10/575,370

Soo-Chang Moon

HIJAZ, OMAR F

<b>Office Action Summary</b>	<b>Application No.</b> 10/575,370	<b>Applicant(s)</b> MOON, SOO-CHANG	
	<b>Examiner</b> OMAR HIJAZ	<b>Art Unit</b> 3633

**FIGURE 2A**

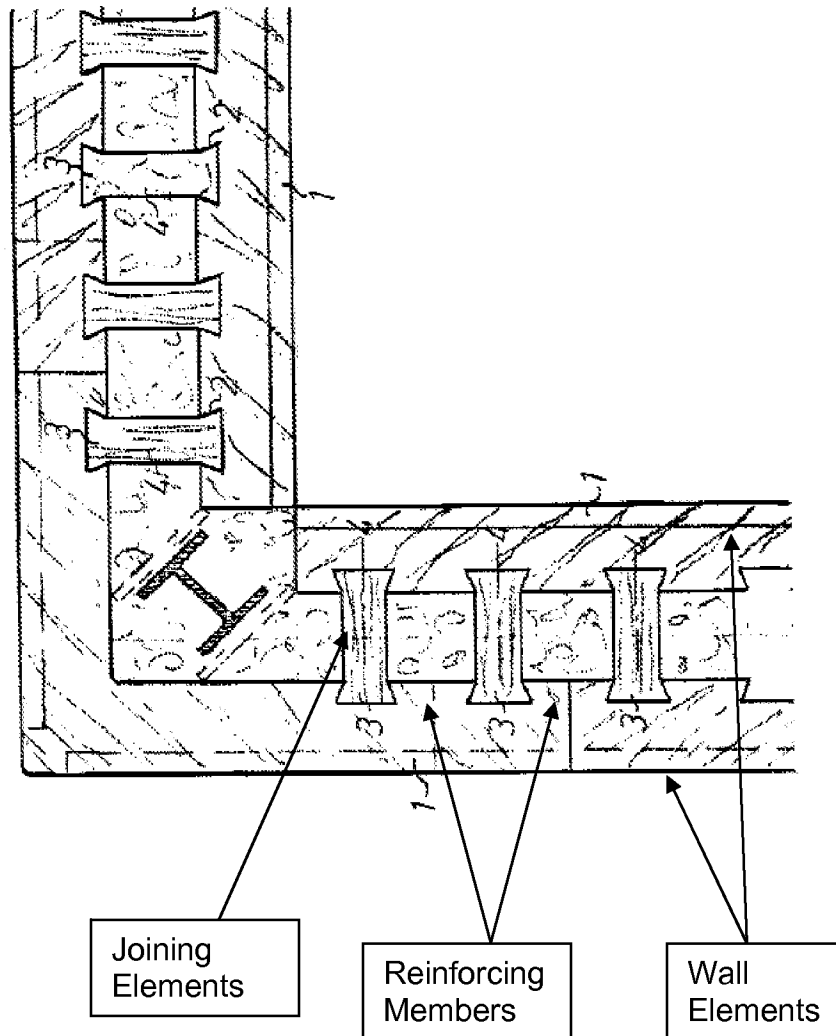
As per claim 1, Olsen et al. teaches a form panel system (building kit for wall construction; abstract) comprising: compression cement boards (wall elements; figure 2A below) adapted to be disposed opposite to each other and spaced at a predetermined distance from each other (as illustrated, the wall elements are opposite each other and spaced; figure 2A); and having a plurality of reinforced members integral thereto (as illustrated the reinforced members are integral to the wall elements; figure 2A below), extension compression cement boards (the opposing wall element; figure 2A below) having a plurality of reinforcing members integral thereto (as illustrated the

reinforcing members are integral to the reinforced members; figure 2A below), said extension cement boards adapted to be disposed adjacent to each of the opposite compression cement boards (as illustrated, the wall elements are opposing one another; figure 2A below) and being sealably connectable to the respective compression cement board at one end and the adjacent extension compression cement board at another end (as illustrated, the opposing wall elements are connected to each other; figure 2A below) the reinforcing members of the compression cement board are provided on a surface which faces the opposite compression board (as illustrated, the reinforcing members are provided on the surface of the wall elements; figure 2A below); a portion of the reinforced member of one of the compression cement board and the extension compression cement board extends beyond the respective surface to sealably overlap on the other of compression cement board or the extension compression cement board thereby covering a portion of a junction between the compression cement board and the extension compression cement board (as illustrated, a portion of the reinforced members extend between the opposing wall elements covering a junction therebetween; figure 2A below); and the remaining portion of the junction is covered by a plurality of foamed polystyrene (expanded polystyrene or EPS; col. 2, lines 57-58); and concrete is injected and cured into the space between the compression cement boards (core of concrete; col. 1, lines 56-57).

In addition, Olsen et al. discloses foamed plastic panels disposed at the inside surface of at least one of the opposite compression cement boards (reinforced members; figure 2A below; form-cast EPS blocks; col. 1, lines 54-57), but fails to disclose each of the foamed plastic panels being formed by means of electric heating wires.

As per claim 15, Olsen et al. teaches a thickness of at least two side edges of each of the foamed plastic panels is smaller than any other portion of the foamed plastic panel (as illustrated, different portions of the edges of the reinforcing members are of different thicknesses; figure 2A below).

As per claim 6, Olsen et al. discloses at least one cement board reinforcing member linearly attached to the respective compression cement boards (as illustrated the reinforced members are integral to the wall elements; figure 2A below).

As per claim 11, Olsen et al. teaches the opposite compression cement boards, are secured at a predetermined distance by a plurality of two-plane connecting members (as illustrated, the opposing wall elements are spaced apart and connected by joining elements 4; figure 2A below); the foamed plastic panels are provided at both

As per claim 10, Olsen et al. discloses extension compression cement boards (the opposing wall element; figure 2A below) having a plurality of reinforcing members integral thereto (as illustrated the reinforcing members are integral to the wall elements; figure 2A below), said extension cement boards adapted to be disposed adjacent to each of the opposite compression cement boards (as illustrated, the wall elements are opposing one another; figure 2A below) and being sealably connectable to the respective compression cement board at one end and the adjacent extension compression cement board at another end (as illustrated, the opposing wall elements are connected to each other; figure 2A below), wherein the panels are also attached, to the extension compression cement boards (as illustrated, the joining elements 4 are attached to the wall elements; figure 2A below), said panels are connected to each other on the same plane (as illustrated, the wall elements are connected on the same plane; figure 2A below) and the panels are provided at both ends thereof with supporting grooves or slits (grooves 2); and concrete moves in the space between the opposite members such that the concrete is mixed and cured (core of concrete; col. 1, lines 56-57).
